# **Rozelle Laneways**

### [Redevelopment of the Tigers Leagues Club Site]

Planning Panel Design Response [June 2020]

### Northwestern Site

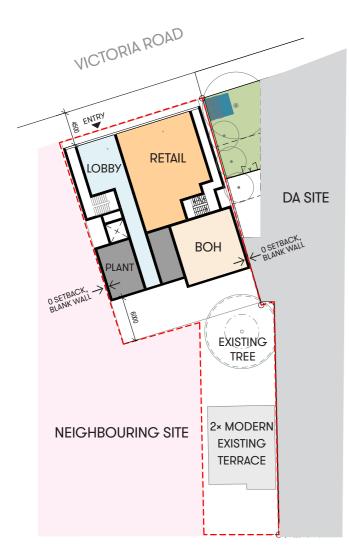
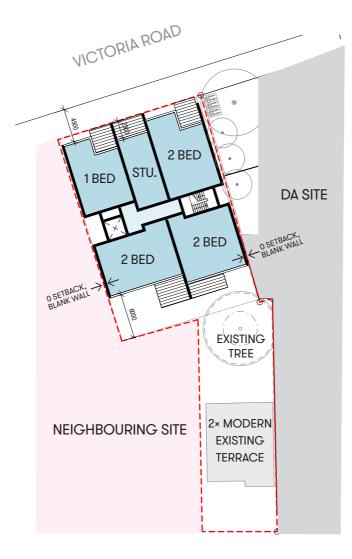
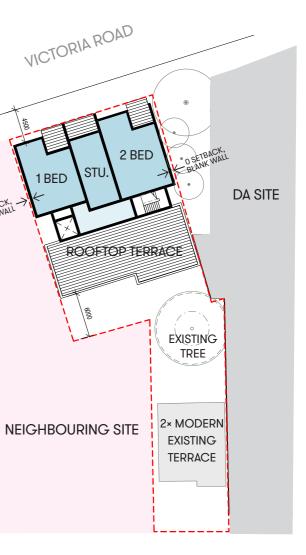
A concept design for the neighbouring property basement carpark is required to demonstrate the connection is feasible/suitable incl. for any loading requirements. Documentation to address additional traffic generation is required and identify impact to car parking numbers due to any design changes.

Evidence that the connection would occur at a level favourable for a basement level on the

A plan that demonstrates a functional basement car parking layout on the adjoining

Evidence of how loading/unloading will occur via the subject land for the benefit of the
